PICO BRANCH LIBRARY

ISSUE
PLAN CHECK CORRECTIONS

SHEET TITLE
WALL / ROOF / FLOOR ASSEMBLIES

SHEET NO.
A9.30

1 HR/ EXTERIOR STUCCO WALL G

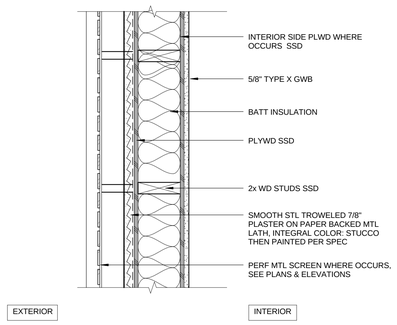
WALL TYPE G1 IS SAME CONSTRUCTION AND REQUIRES
1 HR RATING PER TABLE 702, ITEM 15.1.3

EXTERIOR MASONRY WALL M

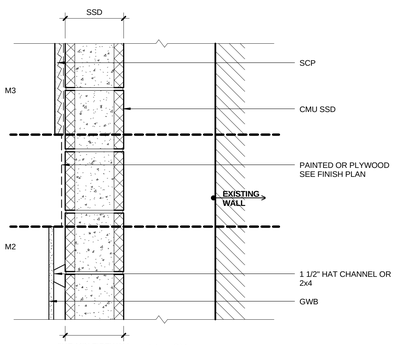
TABLE 720.1
2 HR WALL REQUIRES 4.2" MIN THICKNESS,
1 HR WALL REQUIRES 2.8" MIN THICKNESS
